ADVISORY BOARD ON RADIATION AND WORKER HEALTH

SC&A DRAFT REVIEW OF ORAUT-RPRT-0080

Contract No. 211-2014-58081 SCA-TR-2017-SEC010, Revision 0

August 2017

Figure 1. Neptunium Billet Line Area Showing Locations of the Airlocks and Rooms 107B – NBL End and 107F – Regulated Corridor

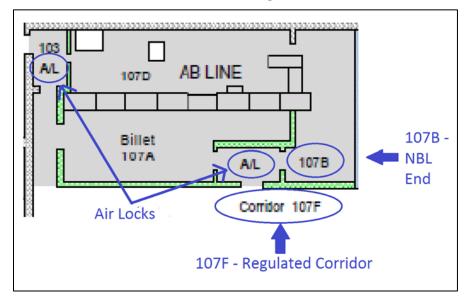
However, the calculated geometric mean (GM) alpha air concentration for the construction area was actually higher than the GM for the 107F – Regulated Corridor, which is directly adjacent to the NBL. In addition, the GM for construction areas was also higher than room 107B – NBL End (end of the NBL). At the calculated 50th percentile, the construction area air samples were numerically the same as the 107F – Regulated Corridor and comparable to the 50th percentile calculated for the 107B – NBL End. Figure 1 shows these two locations.

Observation 3: The calculated geometric mean and 50th percentile values for available air samples in the construction area are comparable and/or bound the calculated air samples from the 107F – Regulated Corridor and the 107B – NBL End locations. These locations are either directly adjacent to the NBL (107F – Regulated Corridor) or inside the airlocks of the NBL (107B – NBL End).

Figure 2. Screenshot of Figure 3-1 from RPRT-0080 (NIOSH 2017) Comparing Available Air Sampling to the Construction Progress of PuFF (with SC&A annotation)

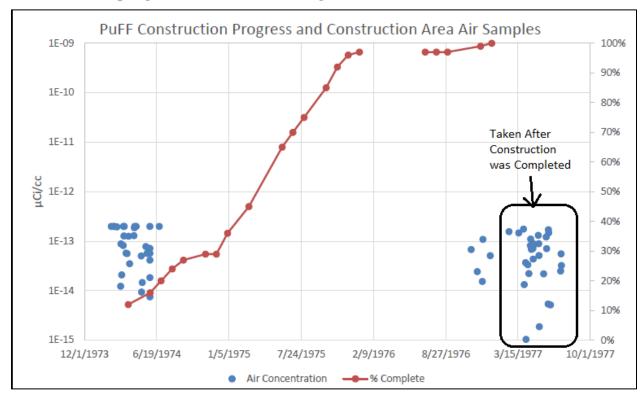
The air sampling results taken in the construction area by date were plotted in Figure 3-1, Section 4.0, of RPRT-0080 (reproduced below as Figure 2). Also plotted is the percentage of PuFF construction that had been completed at the time of the air sampling. It should be noted that most of the air samples shown to the right of the figure were taken after construction was

complete. Aside from a dozen air samples beginning in November 1976, all of the constructionrelated air sampling occurred before July 1974, when only 20% of the construction of PuFF had been completed.

Finding 2: A temporal gap in currently available air sampling in the construction area exists from approximately July 1974 to early November 1976. During this temporal gap, more than 75% of the total construction work for the PuFF was performed.
